**Nuclear Reactor Laboratory**

September 8, 2004  
Docket No. 50-151

**SUBJECT: Eliminate Reactor Health Physicist Position and one hour on-call requirement from Technical Specifications.**

**Justification for September 2004 Changes to UIUC Nuclear Reactor Laboratory Technical Specifications, Docket 50-151**

CHART I

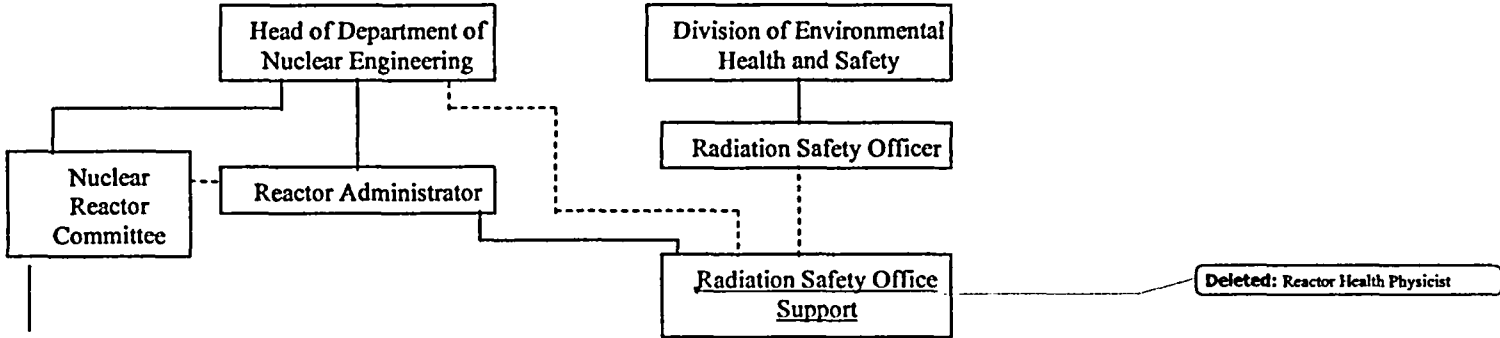
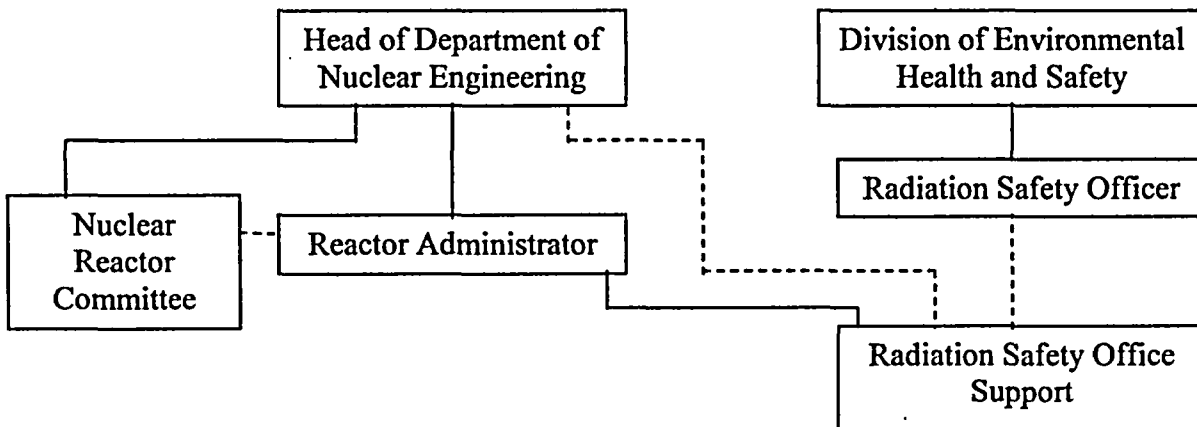
2. *The Reactor Health Physicist is replaced by "Radiation Safety Office Support".* Deleted: Reactor Health Physicist
3. *The position of Reactor Health Physicist at the reactor has been eliminated.* Deleted: 2. Reactor Health Physicist. This individual shall meet the requirements of ANSI/ANS-15.4-1988 "American National Standard for the Selection and Training of Personnel for Research Reactors" for a Level Three individual in addition to training in health physics.†

CHART I: Administrative organization of the reactor facility. Dashed lines indicate reporting paths outside the operational chain of supervision, indicated by solid lines.

CHART I: Administrative organization of the reactor facility. Dashed lines indicate reporting paths outside the operational chain of supervision, indicated by solid lines.
